From: Elaina Smouha [REDACTED]
Sent: Thursday, 13 January 2011 4:52 PM
To: Allen Peter; pborrows@[REDACTED] Reilly Bob; [REDACTED] Humphrys Gary [REDACTED]
Subject: Fwd: Cooper Flood Mitigation Manual review
Attachments: Scan 1.pdf; Brian Cooper - final report.docx; Brian Cooper - final report attachment.xlsx; Wivenhoe Dam Background_Briefing_Jan_2011[1].docx

Independent review of Somerset and Wivenhoe Dam operations against the *Manual of Operational Procedures for Flood Mitigation at Wivenhoe Dam and Somerset Dam*

Wivenhoe Dam – Development of Flood Operational Rules

Wivenhoe & Somerset Dams – Storage Level Behaviour (as presented in Technical Situation Reports)

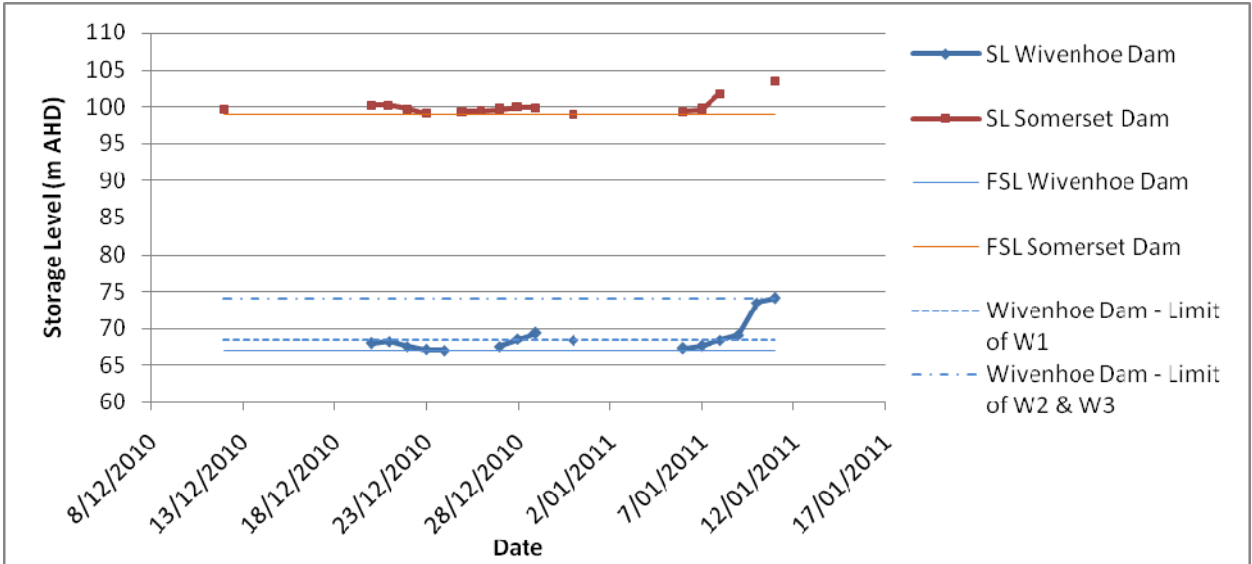
The Technical Situation Reports comply with the requirements of the new Communication Protocol. However, I feel that there could be more consistency in the information presented. There seem to be gaps in information presented such as storage levels (see spreadsheet and graph in Attachment A). It would be useful to specify the minimum information required to be presented in the Technical Situation Reports (storage levels, inflows, recent/current rainfall, forecast rainfall, releases from dams, estimated flows from downstream tributaries, current flood operating strategy for each dam and proposed change in strategy, gate and regulator operations, state of downstream road crossings etc). Most of the minimum information is already given, but not in a consistent manner. As a means of reviewing processes followed during a flood, it would be useful to present a timeline of the flood event showing graphs of storage levels and other data that can be easily presented in a graphical manner.
